SERVICE BULLETIN REVISION TRANSMITTAL SHEET

TITLE: AIR CONDITIONING - FLOW CONTROL AND INDICATING - REINTRODUCE WIRING BETWEEN

FCV AND SDAC

This page transmits Revision No. 01 of Service Bulletin No. A320-21-1176.

Figure 3, Sheet 1 Config. 01: Modification of wiring in 95VU

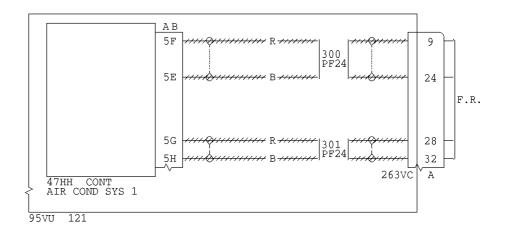
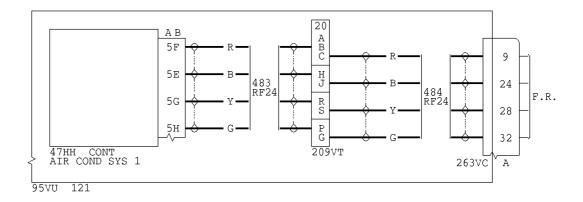
- 3 On the 209VT, install the end clamp removed at paragraph (1) (b) 1.
- 4 Remove the wires as shown on the wiring diagram, Figure 3 Sheet 1 and as given in the Hook-up Chart lines :
 - 1 thru 4 (Refer to Figure 14 Sheet 1)
- 5 Install the wires as shown on the wiring diagram, Figure 3 Sheets 2 and 3 and as given in the Hook-up Chart lines :
 - 8 thru 16 (Refer to Figure 14 Sheet 1)

Figure 4, Sheet 1 Config. 02: Modification of Wiring in 95VU

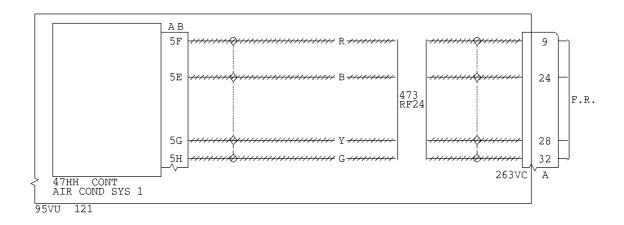
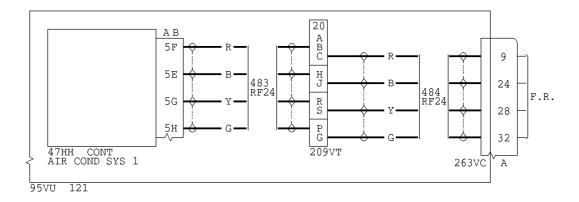
- On the 209VT, install the end clamp removed at paragraph (2) (b) 1.
- 4 Remove the wires as shown on the wiring diagram, Figure 4, Sheet 1, and as given in the Hook-up Chart lines :
 - 1 thru 4 (Refer to Figure 15, Sheet 1)
- $\underline{5}$ Install the wires as shown on the wiring diagram, Figure 4, Sheets 2 and 3, and as given in the Hook-up Chart lines :
 - 8 thru 16 (Refer to Figure 15, Sheet 1)

Figure 5, Sheet 1
Config. 03: Modification of Wiring in 95VU

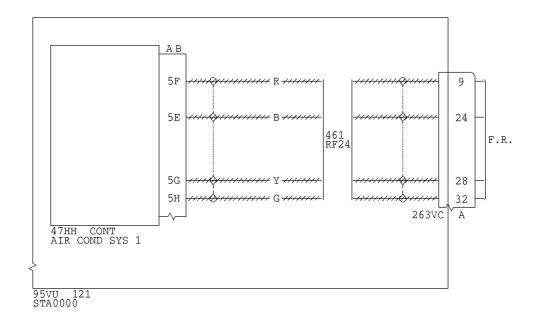
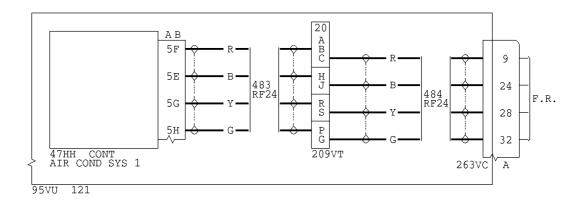
- 3 On the 209VT, install the end clamp removed at paragraph (3) (b) 1.
- 4 Remove the wires as shown on the wiring diagram, Figure 5, Sheet 1 as given in the Hook-up Chart lines :
 - 1 thru 4 (Refer to Figure 16, Sheet 1)
- $\underline{5}$ Install the wires as shown on the wiring diagram, Figure 5, Sheets 2 and 3 as given in the Hook-up Chart lines :
 - 8 thru 16 (Refer to Figure 16, Sheet 1)

Figure 6, Sheet 1
Config. 04: Modification of Wiring in 95VU

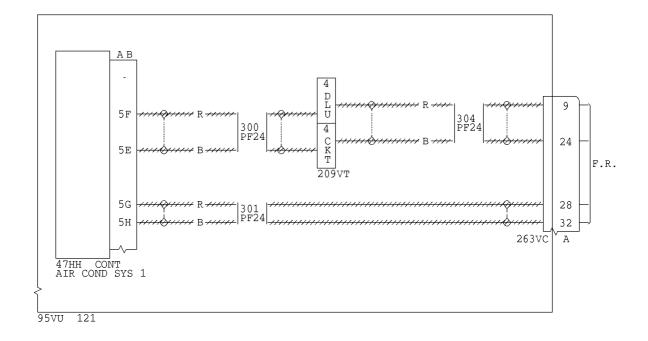
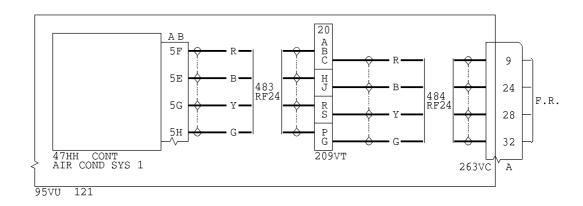
- 3 On the 209VT, install the end clamp removed at paragraph (4) (b) 1.
- 4 Remove the wires as shown on the wiring diagram, Figure 6, Sheet 1, 4, 5, and as given in the Hook-up Chart lines :
 - 1 thru 10 (Refer to Figure 17, Sheet 1)
- 5 Install the wires as shown on the wiring diagram, Figure 6, Sheets 2 and 3 as given in the Hook-up Chart lines :
 - 14 thru 22 (Refer to Figure 17, Sheet 1)

Figure 7, Sheet 1

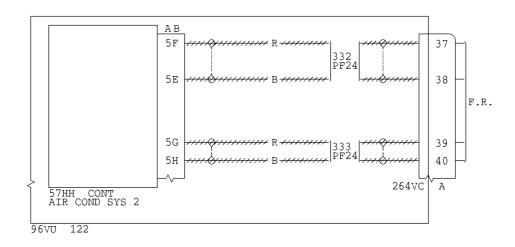
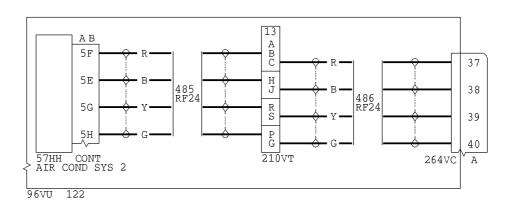
- 3 On the 210VT, install the end clamp removed at paragraph (1) (c) 1.
- 4 Remove the wires as shown on the wiring diagram, Figure 7 Sheet 1 and as given in the Hook-up Chart lines:
 - 1 thru 4 (Refer to Figure 18 Sheet 1)
- Install the wires as shown on the wiring diagram, Figure 7 Sheets 2 and 3, and as given in the Hook-up Chart lines:
 - 8 thru 16 (Refer to Figure 18 Sheet 1)

Figure 8, Sheet 1 Config. 02: Modification of Wiring in 96VU

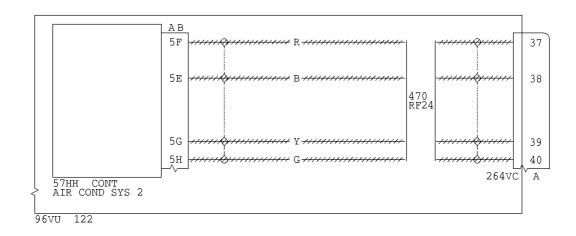
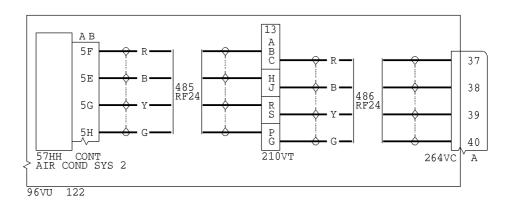
- On the 210VT, install the end clamp removed at paragraph (2) (c) 1.
- 4 Remove the wires as shown on the wiring diagram, Refer to Figure 8, Sheet 1 and as given in the Hook-up Chart lines:
 - 1 thru 4 (Refer to Figure 19 Sheet 1)
- 5 Install the wires as shown on the wiring diagram, Figure 8, Sheets 2 and 3, as given in the Hook-up Chart lines:
 - 8 thru 16 (Refer to Figure 19, Sheet 1)

Figure 9, Sheet 1 Config. 03: Modification of Wiring in 96VU

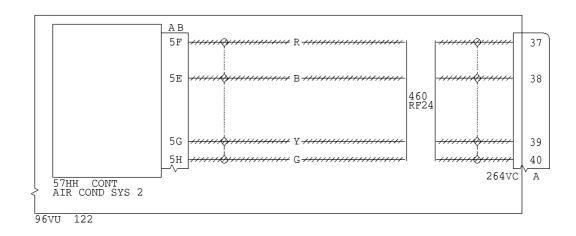
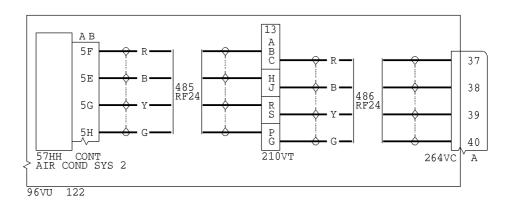
- 3 On the 210VT, install the end clamp removed at paragraph (3) (c) 1.
- 4 Remove the wires as shown on the wiring diagram, Figure 9, Sheet 1 and as given in the Hook-up Chart lines:
 - 1 thru 4 (Refer to Figure 20, Sheet 1)
- 5 Install the wires as shown on the wiring diagram, Figure 9, Sheets 2 and 3, as given in the Hook-up Chart lines:
 - 8 thru 16 (Refer to Figure 20, Sheet 1)

Figure 10, Sheet 1 Config. 04: Modification of Wiring in 96VU

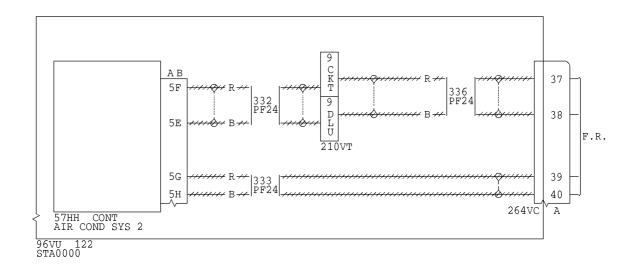
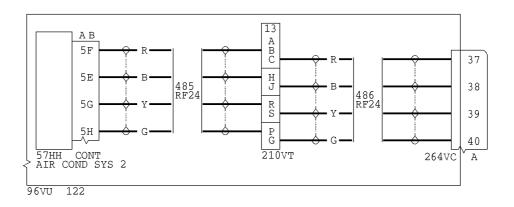
- 3 On the 210VT, install the end clamp removed at paragraph (4) (c) 1.
- 4 Remove the wires as shown on the wiring diagram, Refer to Figure 10, Sheets 1, 4 and 5 as given in the Hook-up Chart lines:
 - 1 thru 10 (Refer to Figure 21, Sheet 1)
- 5 Install the wires as shown on the wiring diagram, Figure 10, Sheets 2 and 3, as given in the Hook-up Chart lines:
 - 14 thru 22 (Refer to Figure 21, Sheet 1)

Figure 11, Sheet 1 Config. 01 thru 04: Modification of Wiring in 80VU

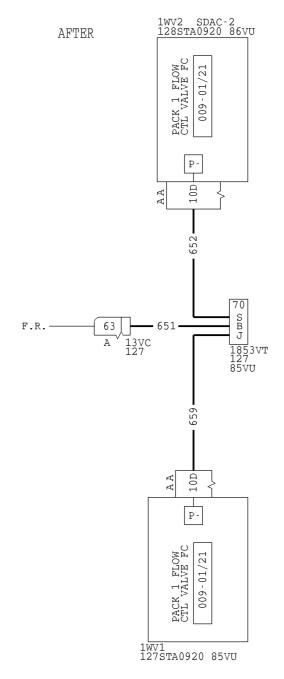
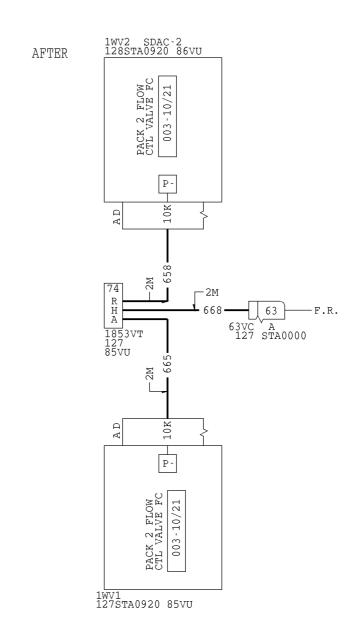
- 1 Install the wires as shown on the wiring diagram, Figure 11, Sheets 1 and 2, and as given in the Hook-up Chart lines:
 - 1 thru 6 (Refer to Figure 22, Sheet 1)
